SERVICE BULLETIN

M-1245A

2008-2009 SPRINGER FORK ACORN STUD SAFETY RECALL 0139

Purpose of Revision

Figure 1. Acorn Stud

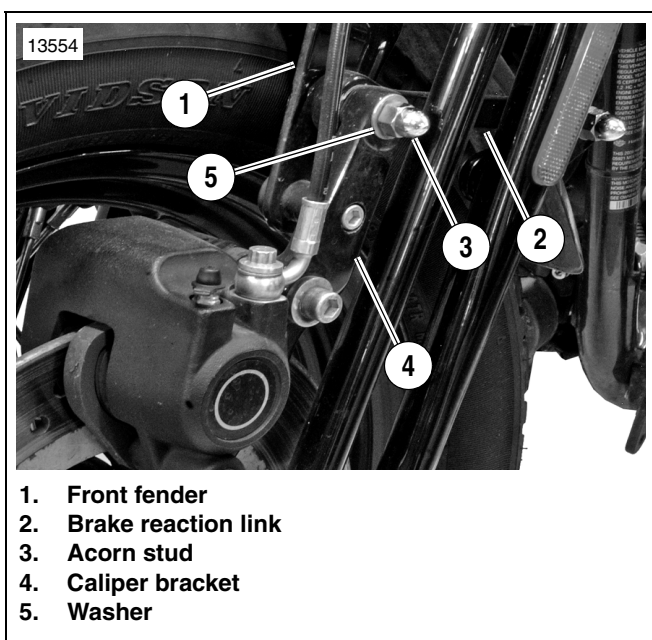
The acorn stud at the brake reaction link on the models listed above that were shipped before April 1, 2009 may fall out during use. If this occurs, the front brake and fender assembly would no longer be adequately retained.

1. Confirm motorcycle is involved and that Campaign 0139 is open.
2. See Figure 1. Support brake reaction link (2) and remove acorn stud (3) and washer (5). Discard acorn stud (3). Retain washer (5).
3. Install **new** acorn stud, supplied in kit, and washer (5) through caliper bracket (4), brake reaction link (2), and front fender (1). Tighten acorn stud to 35-40 ft-lbs (47.5-54.3 Nm).
